Service Note

Product	Description:	Service note no.
Gold Channel	Replace 10 ohm resistors at Mic. Amp. PCB	720 10 T034

Figure 1: Mic. Amp. PCB, PC12905-3

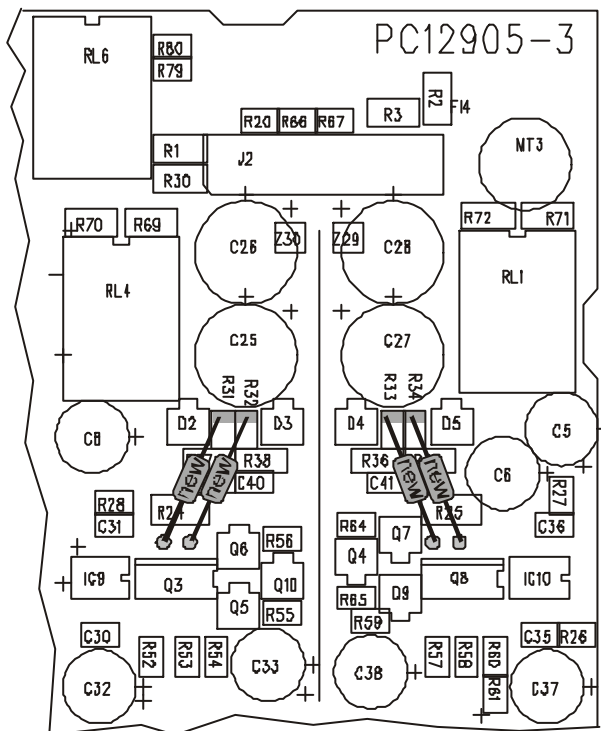
1. Make a backup of the user presets on a memory card.
2. Turn Off Power and Disconnect Power Cord.
3. Remove the top lid by loosen five screws.
4. Remove R31, R32, R33 and R34 on the Mic. Amp PCB, see fig. 1 below.
5. Mount 4 new resistors. Make sure they are soldered to the correct solder pads, see fig. 1. Value for the new resistors is 10 ohm, 1/2W, 5%, SFR16S (TCcode: 100 2100 11)
It's only due to physical size the new resistors are soldered to other pads.
The function of the new resistors is exactly the same as before.
6. Mount the top lid again using the five screws.
7. Connect power.
8. Load in the user presets - if they were deleted.
